**Re: British Columbia Hydro and Power Authority – British Columbia Utilities Commission Inquiry
Respecting Site C – Project No. 1598922 – Final Report**

British Columbia Utilities Commission Inquiry Respecting Site C

Final Report to the
Government of British Columbia

Report errata

Figure 29: Site C Cost to ratepayers Sensitivity

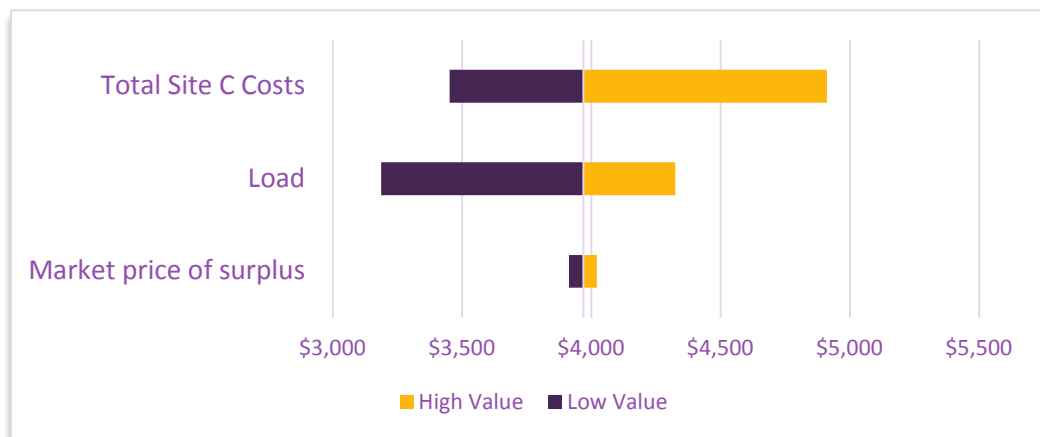
Corrected Figure 29: Site C Cost to ratepayers Sensitivity (p. 169)

Finding: The Panel confirms there is no change to its finding that: “For Site C, the inputs and assumptions that have the greatest impact on rates are the Site C total costs and the magnitude of the load. As with the Illustrative Alternative Portfolio, the market price of surplus energy has much less impact on the costs to ratepayers.”
